## MAULES CREEK COAL MINE

### Water Pipeline Realignment Modification (10\_0138 Mod 2)

**Figure 2: Project Layout showing Water Pipeline**

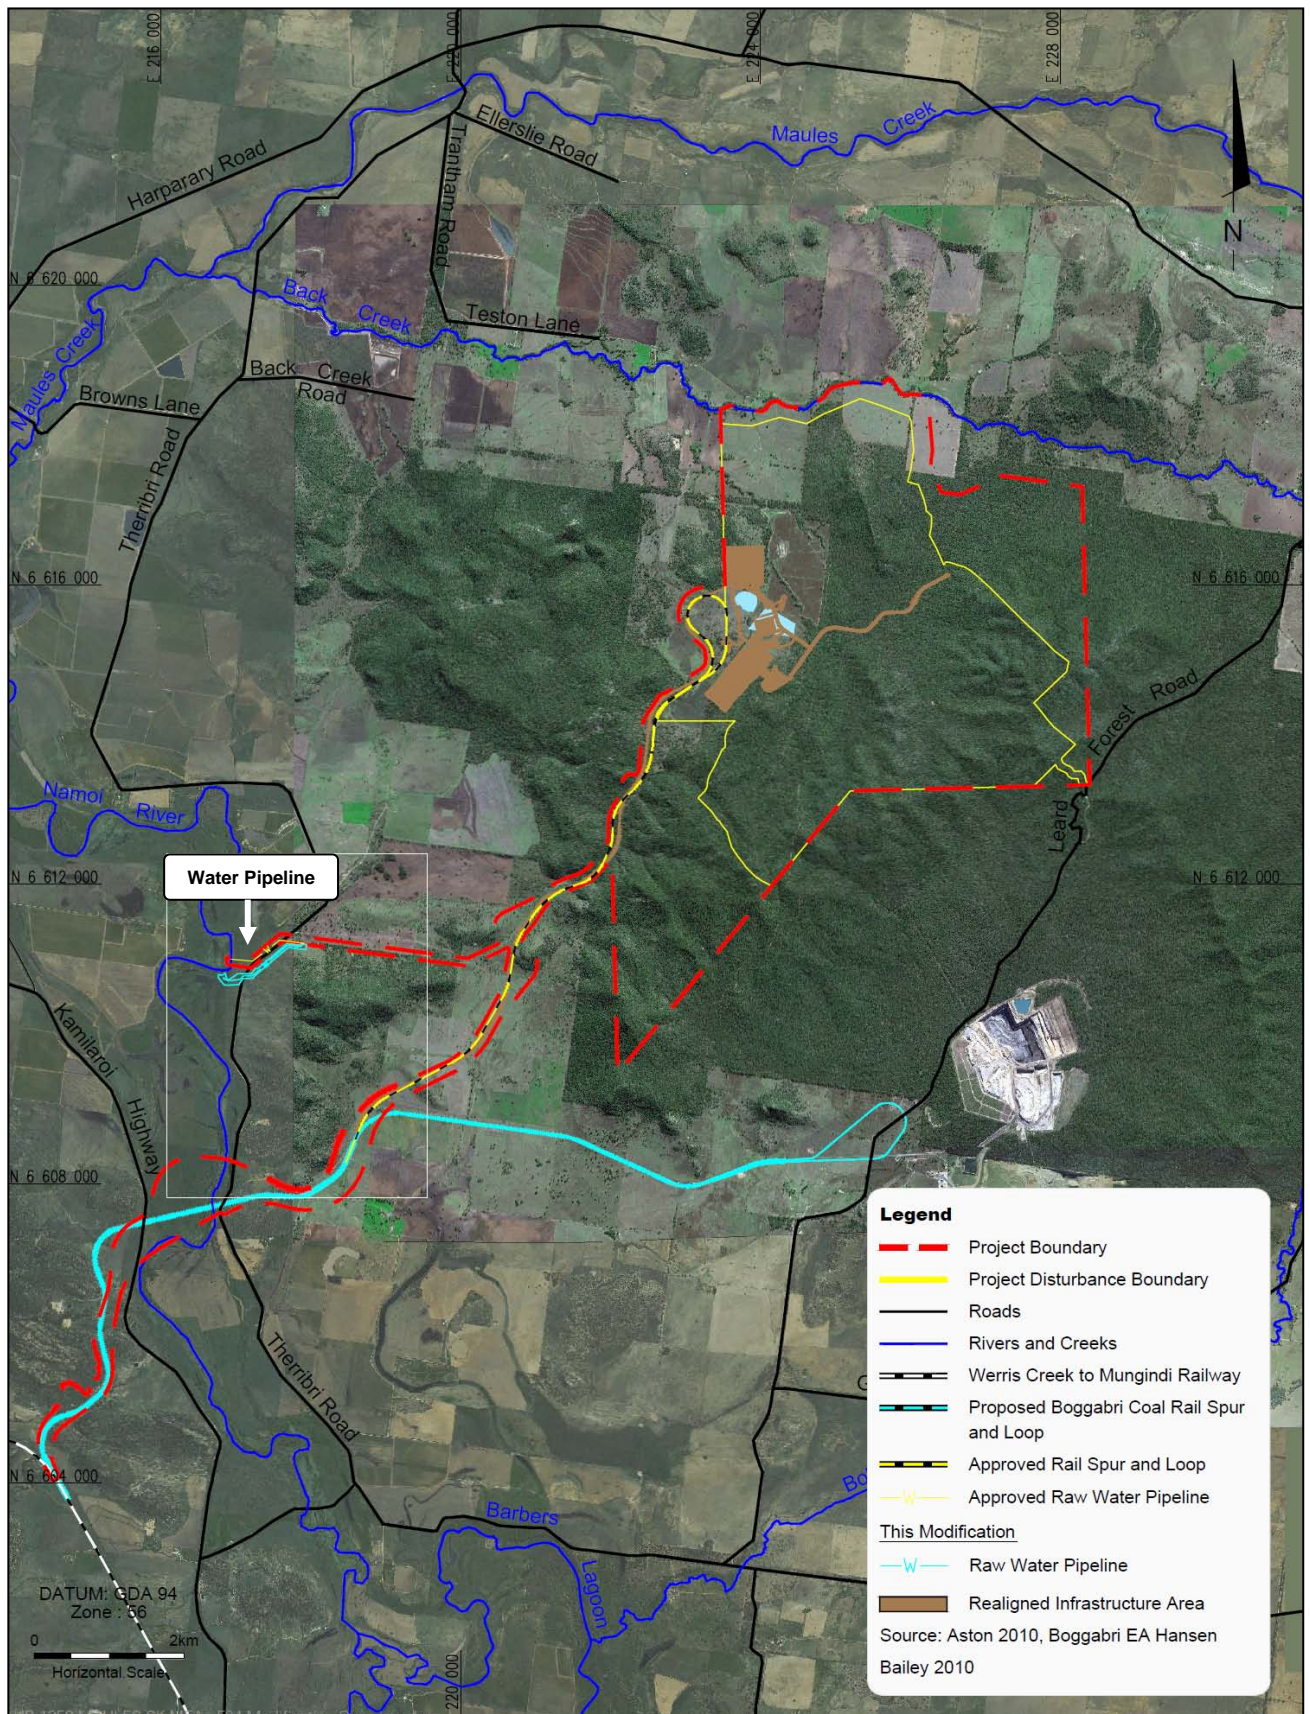
The project approval has been modified once since this time (in 2013), and allows for the development of an open cut coal mine (see Figure 2), including:

The approval also allows for the construction and operation of ancillary infrastructure, including an overland raw water pipeline from the Namoi River to the mine.

**Figure 3: Proposed Modification**

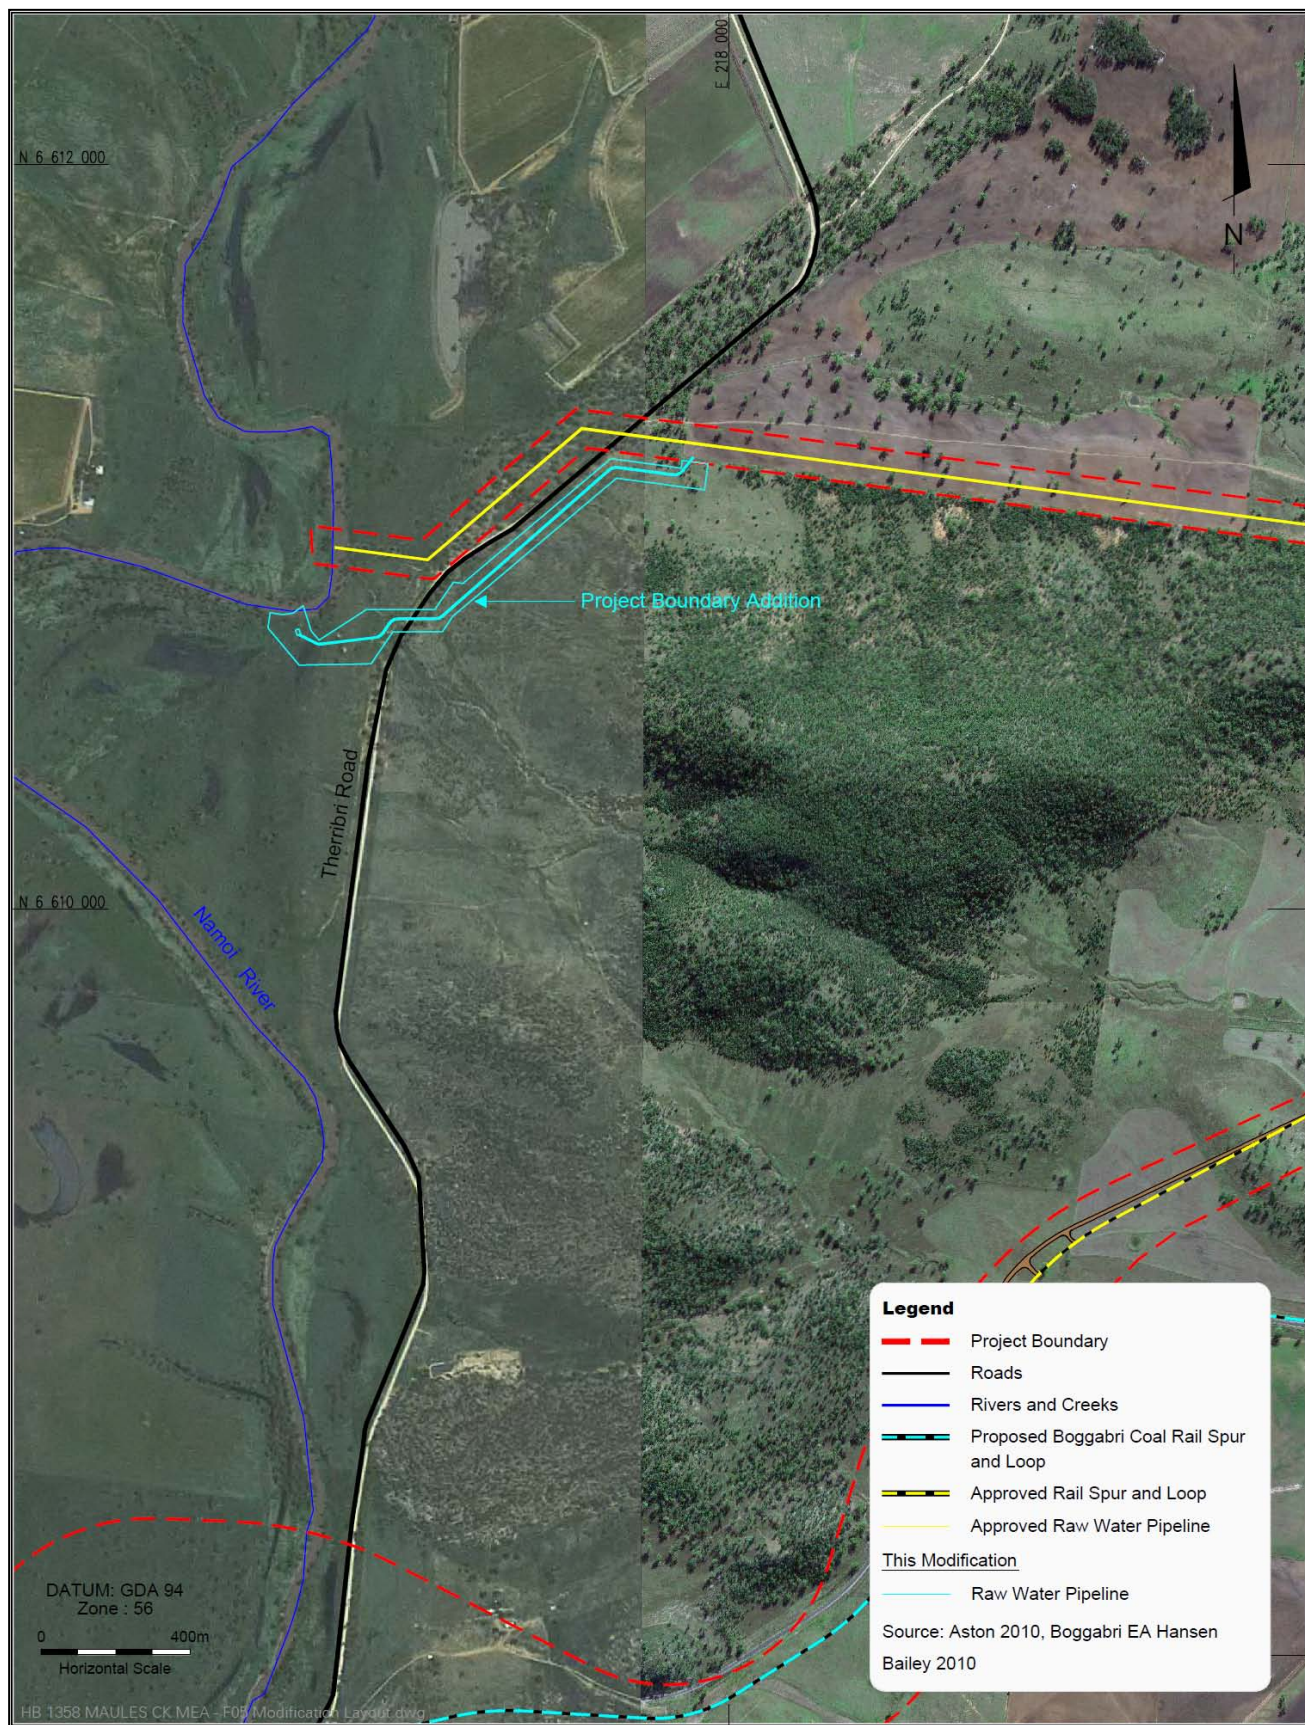
The proposed modification involves (see Figures 2 and 3):

- realigning a 1.3 km section of the water supply pipeline approximately 300 m south of the approved alignment;
- relocating the associated water pump at the Namoi River 300 m south of the approved location; and
- a minor amendment to the project boundary to accommodate the proposed realignment.

The minor realignment of the western-most portion of the pipeline would allow it to traverse land owned by MCC, with the exception of Therribri Road which is owned by Narrabri Shire Council.

The proposed pipeline would have a nominal diameter of 315 mm and would be installed directly on the ground surface over a 2 day construction period. The realignment would not result in the clearance of any vegetation, and the only direct ground disturbance would occur when the proposed pipeline intersects with (and crosses beneath) Therribri Road.
